IEEE P802.1CBdb
(individual contribution)
March 13, 2019

Frame Replication and Elimination for Reliability — Amendment:

Extended Stream identification functions

Figure C-5—Protocol stack for relay system B, proxying for End System A, in Figure C-4

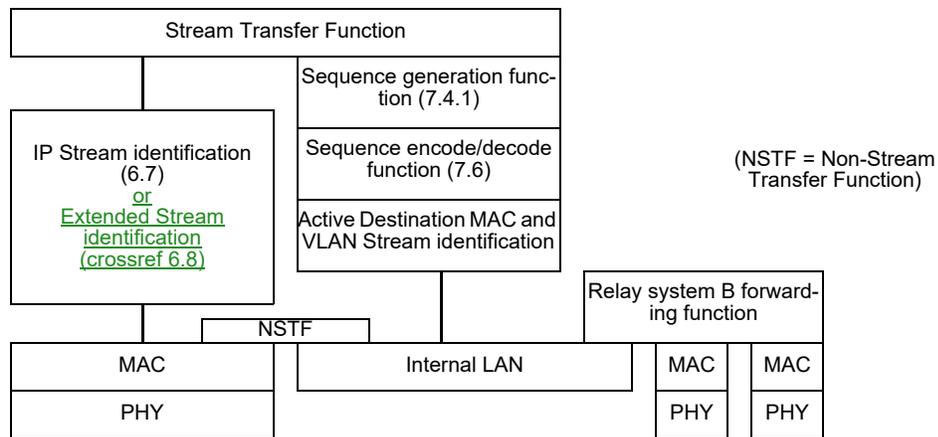
5 *Change 3rd paragraph of clause C.2, and Figure C-5 as shown:*

6 Figure C-5 illustrates relay system B in Figure C-4. As the packets enter from the left, from End System A,
 7 they pass first through a Stream identification function [IP Stream identification (6.7), or Extended Stream
 8 identification (crossref 6.8)], which identifies the Stream. The Stream Transfer Function delivers the packet
 9 with all TSN parameters, including the stream_handle subparameter, to the Sequence generation function
 10 (7.4.1, marked “Seq.” in Figure C-4), which adds a sequence_number subparameter with a steadily-
 11 increasing integer sequence value (modulo the size of the packet field carrying the sequence_number). The
 12 sequence_number subparameter is encapsulated into the packet by the Sequence encode/decode function
 13 (7.6). A Stream identification function [this time, Active Destination MAC and VLAN Stream identification
 14 (6.6)] modifies the two packets’ destination MAC addresses and VLANs for identification through the

15 bridged network. Relay system B’s forwarding function then outputs the two packets on two different ports.
 16 The external form of the packets are labeled differently, as indicated by the italic numbers 26 and 31 in
 17 Figure C-4.
